REFERENCE	BT_2011_FR20_10_UK
DATE	12th May, 2011
SUBJECT	actuator spring modification
PART	GB actuator

### 1. Actuator spring modification

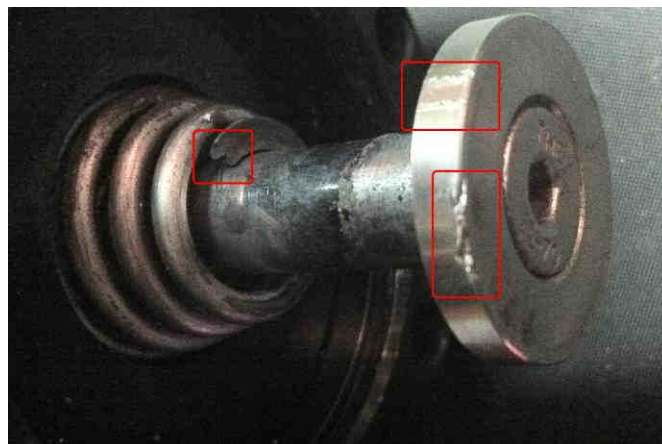
The spring which is at the back of the actuator may break under specific conditions, causing gearshift issues. For this reason, Renault Sport recommends to remove the rear housing of the actuator to check if the spring is already broken or not.

If yes, simply remove the broken part from the housing and check if the axle washer and the inner side of the housing are clean.

If the spring is not broken yet, it is mandatory to modify it as described below:

The red part must be removed (aprox. 5mm)
